Comments on the Draft Report NIST NCSTAR 1-9: “*Structural Fire Response and Probable Collapse Sequence of World Trade Center Building 7*”, issued by NIST August 21st, 2008

(Revised and Extended Version of Comments Issued September 11th 2008)

F. R. Greening

Figure 1: WTC 7 Drop Distance vs. Time Plots

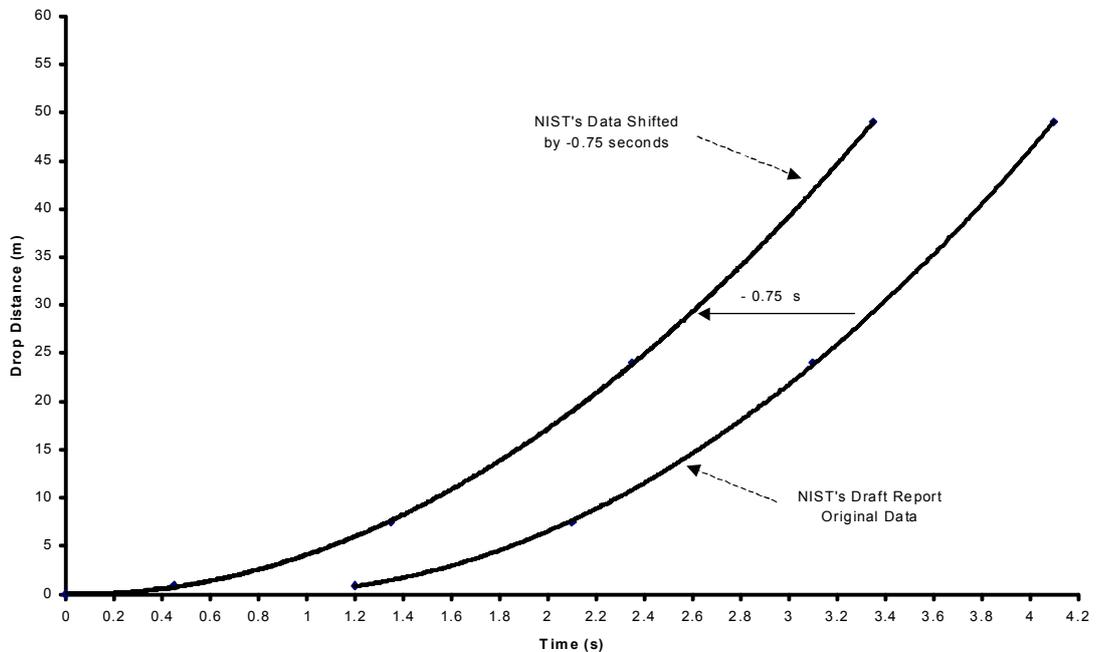
When these, and additional data points are plotted on linear graph paper a smooth drop distance vs. time curve is obtained but the curve does not extrapolate well to $t = 0$. However, a simple subtraction of 0.75 seconds from NIST’s times, equivalent to the global collapse commencing 7.65 seconds after the east penthouse collapsed, produces a curve that passes almost directly through the origin, (i.e. zero drop distance at t_0), as shown in Figure 1 below.

It is important to note that the time-shifted collapse curve shown in Figure 1 is in good agreement with other data on the collapse rate of WTC 7 that have been published on a number of internet sites. In addition, an energy transfer calculation in which the crush-up of the upper 39 floors of WTC 7 is modeled with an energy to collapse each floor of 1 GJ, leads to an acceleration, **a**, given by:

This result is also in good agreement with the studies I have noted above. Thus there appears to be a consistent trend among non-NIST researchers to find, (at least for the first 4 seconds of collapse of WTC 7), a roofline acceleration in the range 8.5 to 9.5 m/s², rather than the value of 5 - 8 m/s² favored by NIST. I would therefore ask NIST to reconsider the analysis presented in Section 12.5.3 of the *Draft Report*, and hopefully adjust its findings to be in better agreement with the vast majority of existing studies of the collapse time of WTC 7.
